MIL-I-23145B
AMENDMENT 3
16 October 1985
SUPERSEDING
AMENDMENT 2
17 January 1984

MILITARY SPECIFICATION

INFLATION ASSEMBLIES, LIFE PRESERVER

This amendment forms a part of Military Specification MIL-I-23145B, dated 15 January 1982, and is approved for use by-all Departments and Agencies of the Department of Defense.

FIGURE 3. **PIERCING** PIN, **SEAT SEAL** GASKET, **AND** SET SCREW DETAILS **FOR TYPE I** AND TYPE III INFLATION ASSEMBLIES

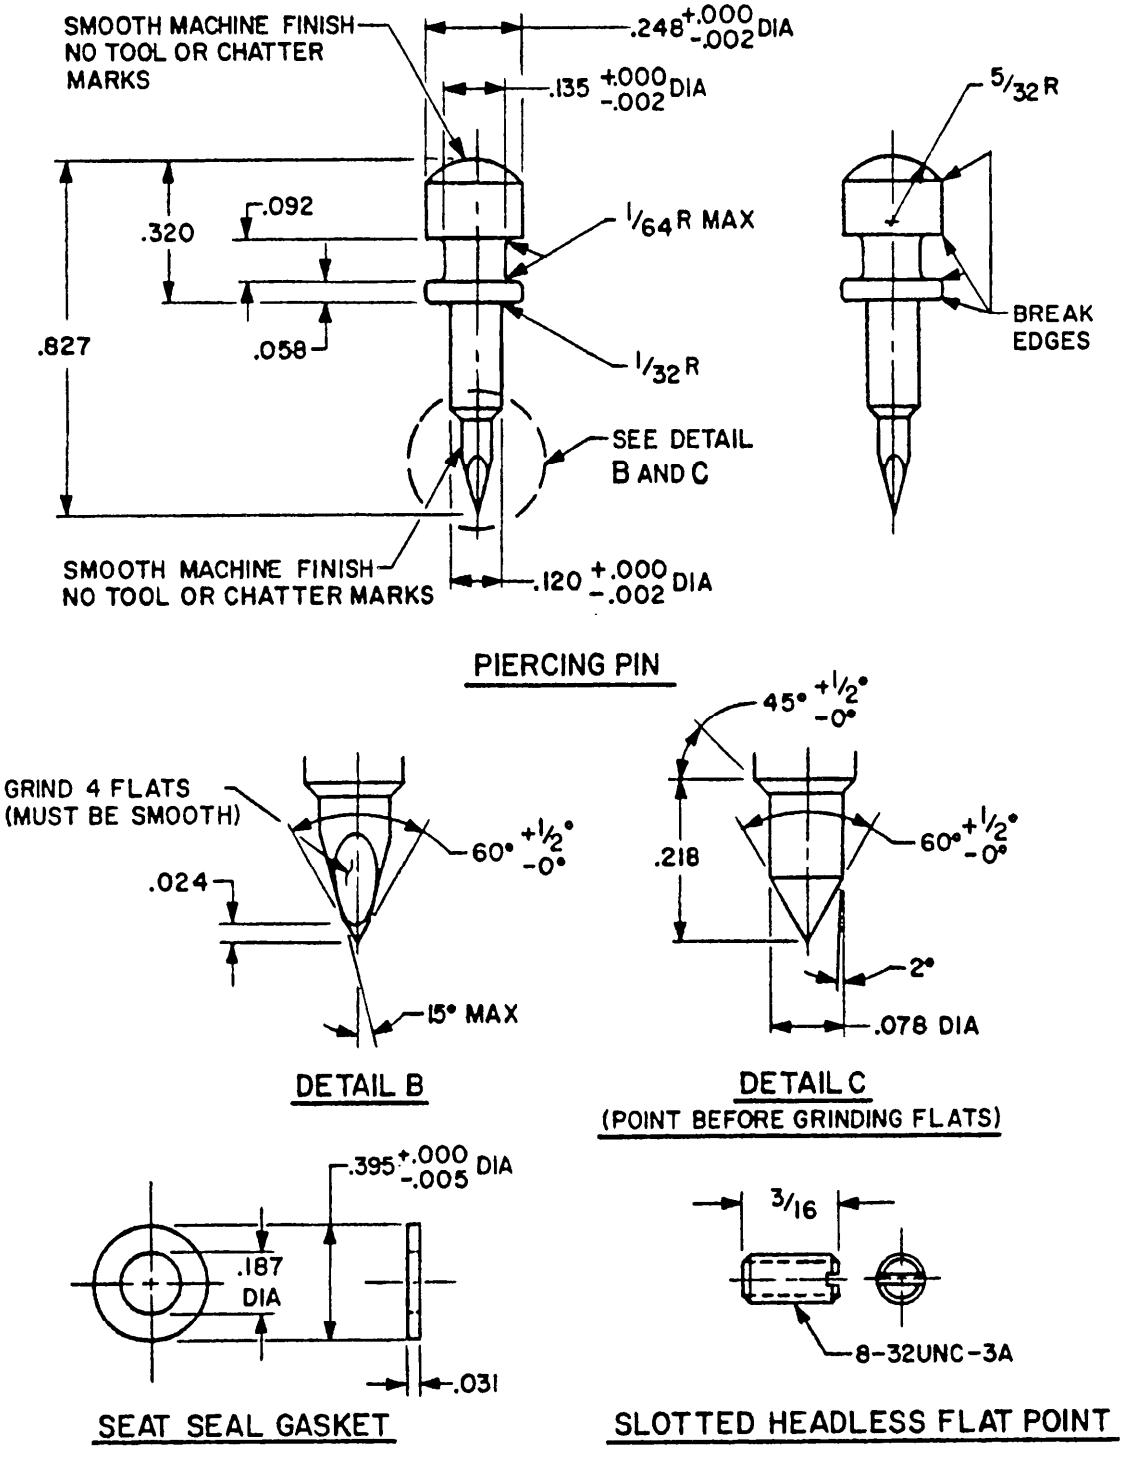
Add paragraph: "3.3.2.2.4 Type I and 111. When specified, the Type I and III inflation assembly set screw shall be a slotted, headless type, with a flat point, conforming to Figure 3. Unless otherwise specified, the Type I and III inflation assemblies shall not contain the set screw."

Delete Figure 3 of MIL-I-23145B and substitute Figure 3 of this Amendment.

FIGURE 9. SECTIONS H-H AND J-J FOR TYPE III INFLATION ASSEMBLY

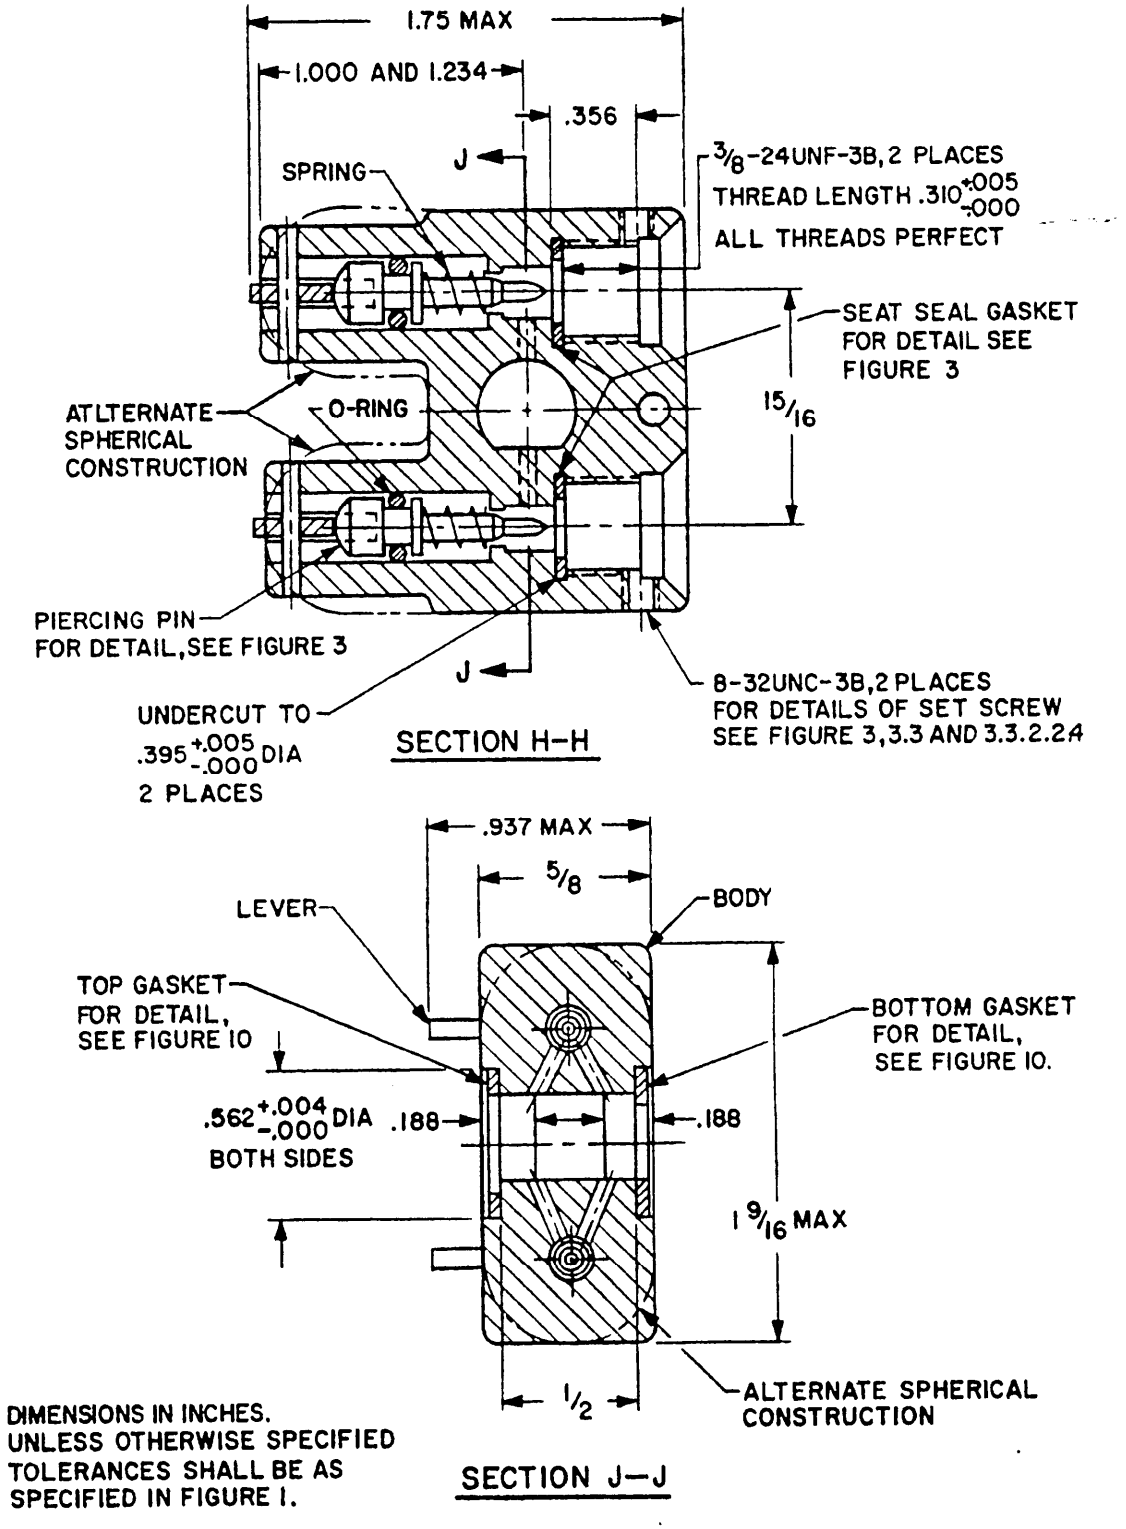
Delete Figure 9 of MIL-I-23145B and substitute Figure 9 of this Amendment.
